Lemon Creek Ranch Lift Station RFCSP
Solicitation Number: CO-00490
Job No.: 21-3000

ADDENDUM 2
December 6, 2021

1
TRANSVERSE RESERVOIR SECTION
 SCALE: 3/8" = 1'

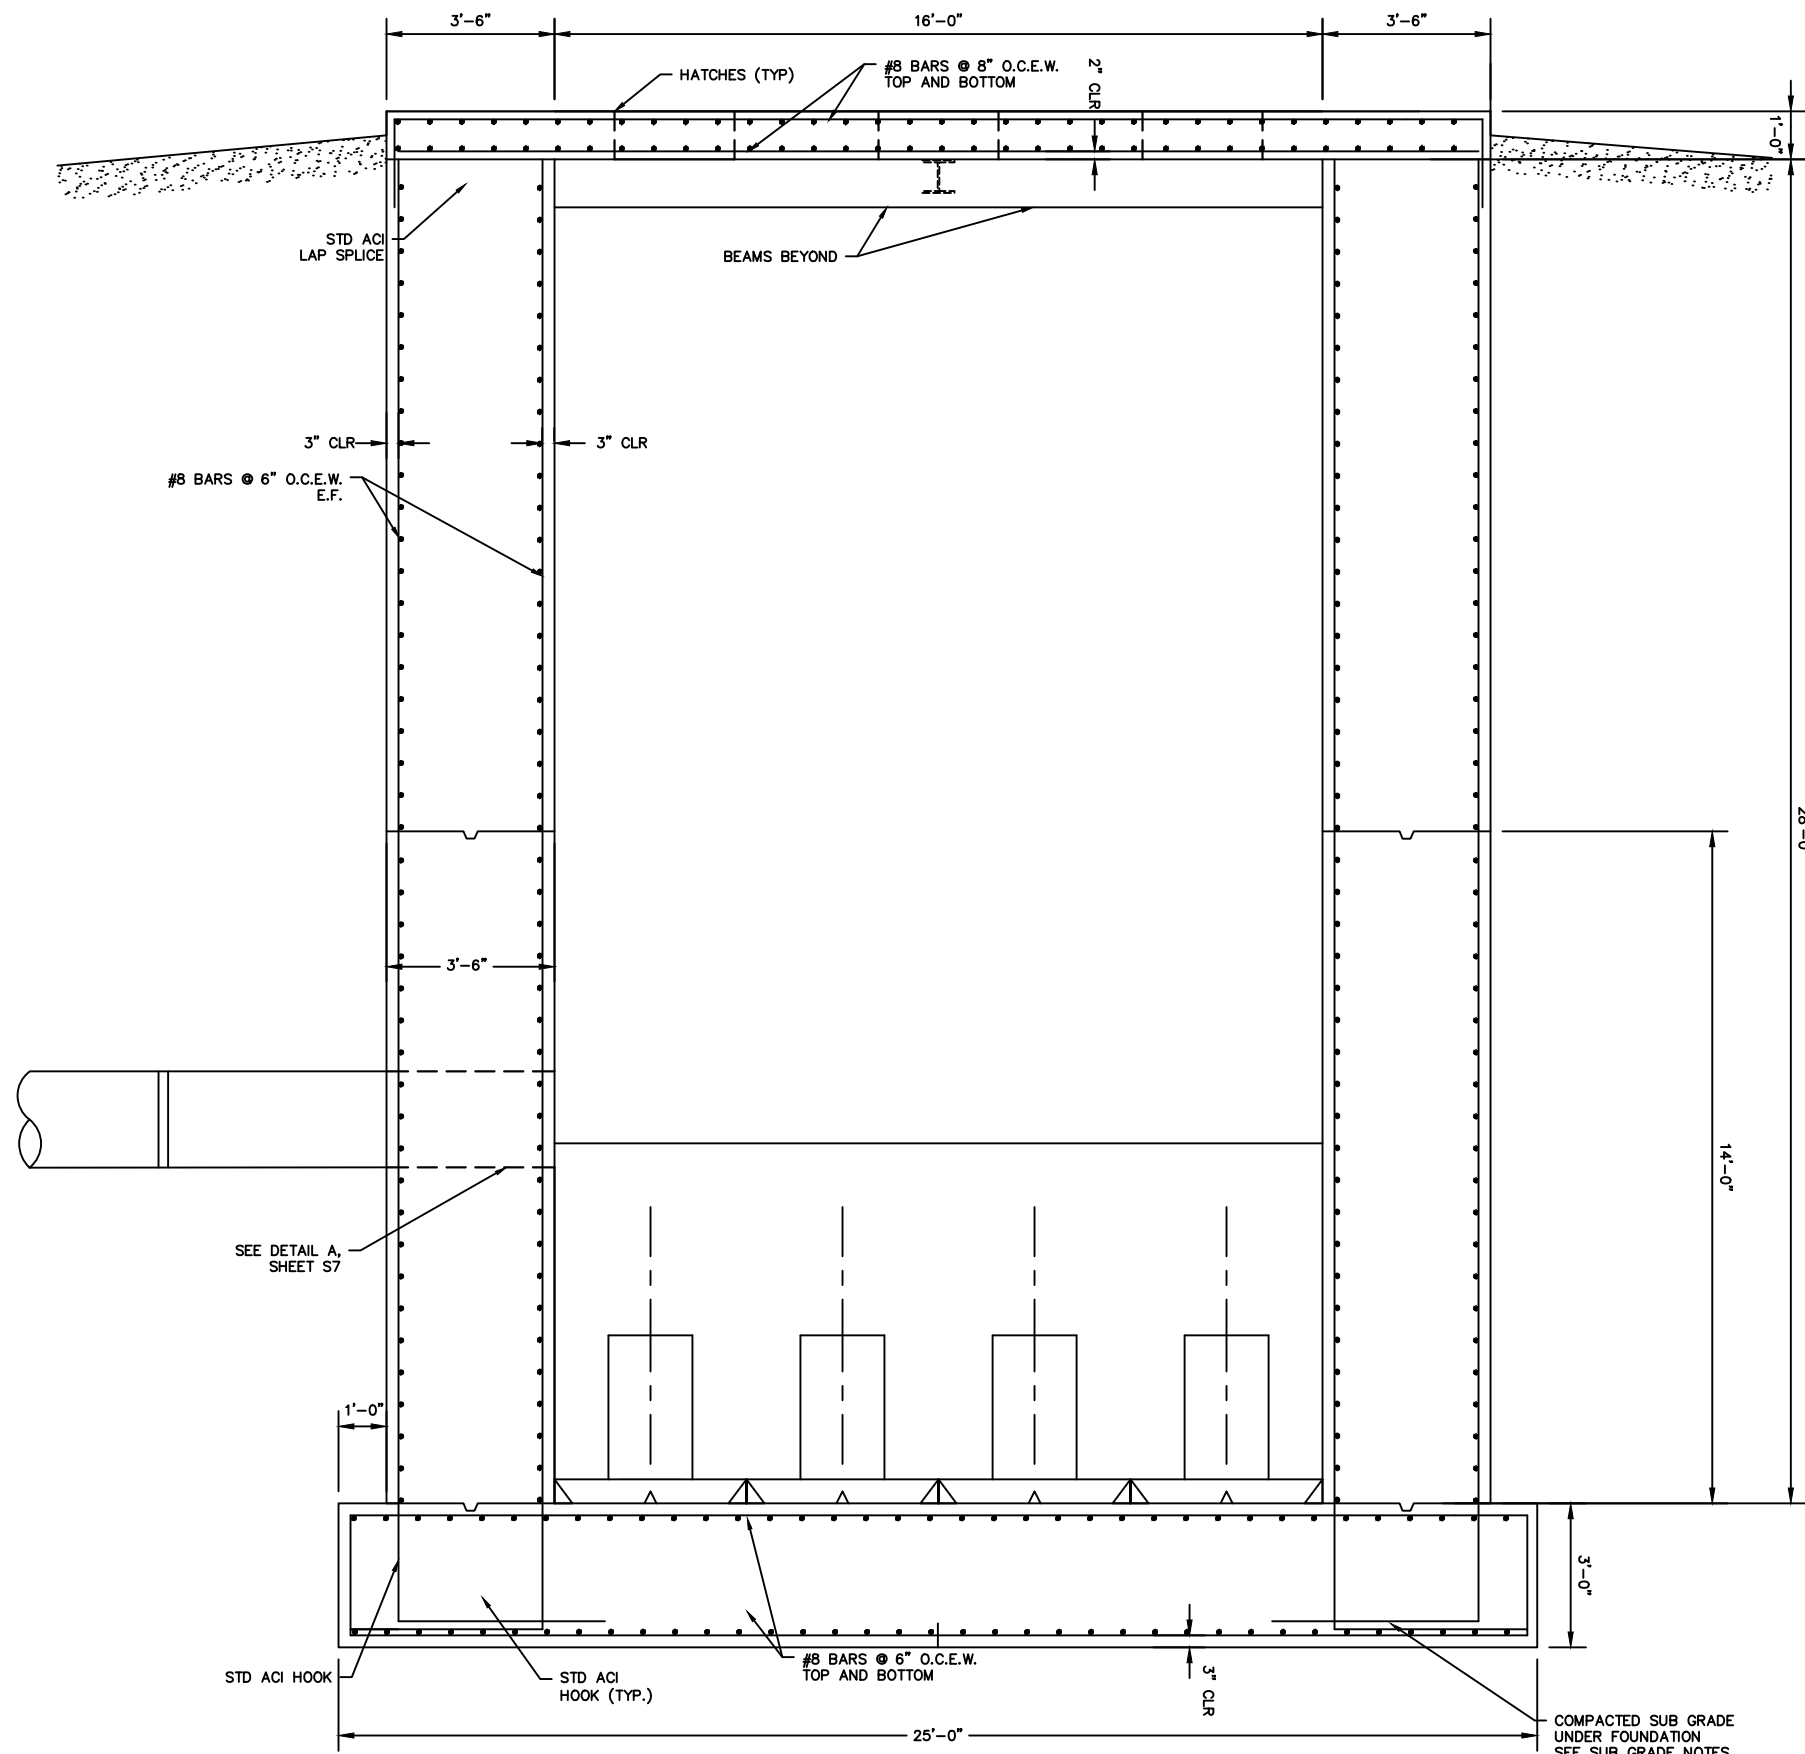
The unit cost for Alternate Bid Item 1A should include all lift station costs with construction of the lift station wet well with thicker concrete walls (42-inch thick) than the base bid as shown in Plan sheets S1-A, S2A, S3A, S5A, S6-A, and S7-A.
